SUBJECT: 25-040 Loaf Land Subdivision - Comment Response

Thank you for your continued review of the Subdivision Application Permit (SP 4103) for Loaf Land Subdivision in Coplin Plt.. The team recently received the additional review comments from LUPC in regard to this application, dated August 27, 2026. These comments can be seen below in *italic*, followed by Main-Land's response in regular typeset. Updated or amended exhibits have been provided as attachments.

**STREAM PLAN &
PROFILE**

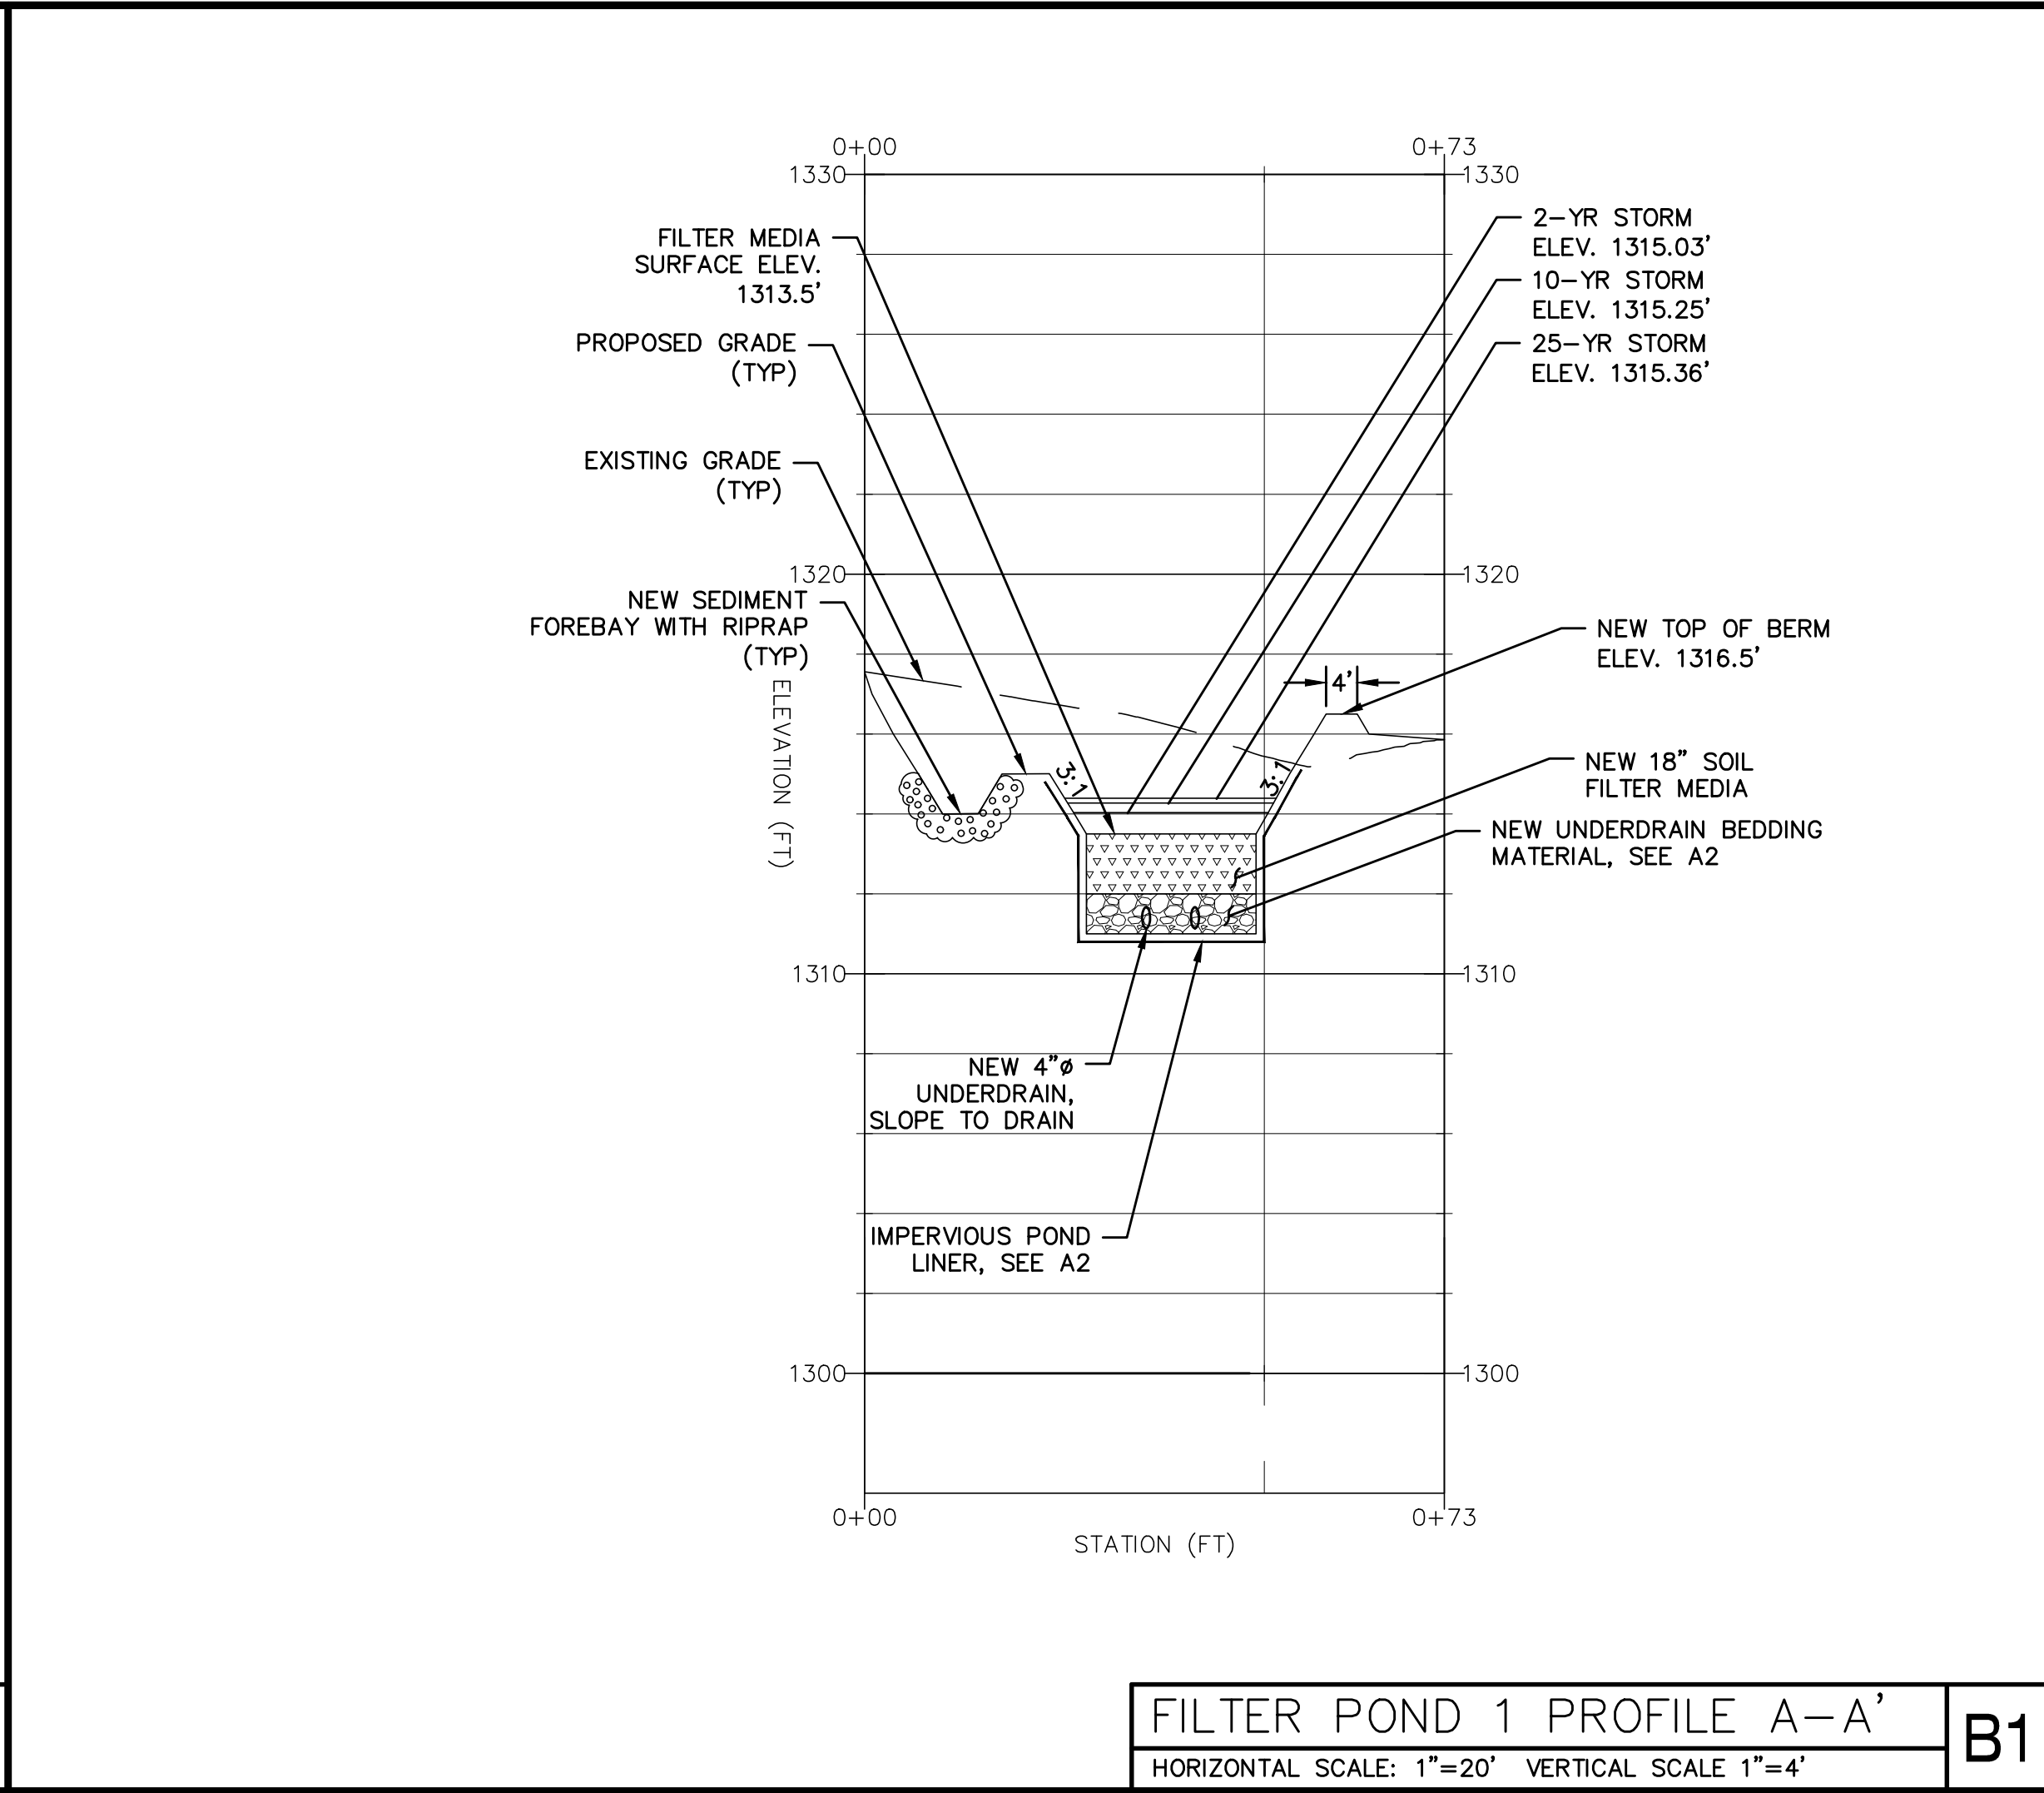
- *On Plan C5.3 (Stream Plan & Profile), clarify the design of the wingwall and how wetland impacts will be avoided during construction (see Sebago Technics review comment IV.11 on Sheet C5.3).*
 - *Sebago Response: The stream profile appears to indicate the need for a 7 foot-tall wing wall on the outlet side. The plans should better depict the design intent of this wingwall and how wetland impacts will be avoided during its construction. Silt fence is also shown through the wetland in this area with no stated wetland impact in this area. Additionally, the design plans include lengths of side slopes that are at 2H:1V or steeper. It should be shown on the grading plan which slope stabilizing measures are to be used and their extents where the side slope exceeds 3H:1V.*

The design plans have been updated accordingly. The wing wall design has been reduced to consist of a 4' wall, an acceptable height for a boulder wall installation by the contractor. The

siltfence and grading has been adjusted to provide more clearance adjacent to wetland. Lastly, the steeper sections have been indicated on C3.1 Grading Plan.
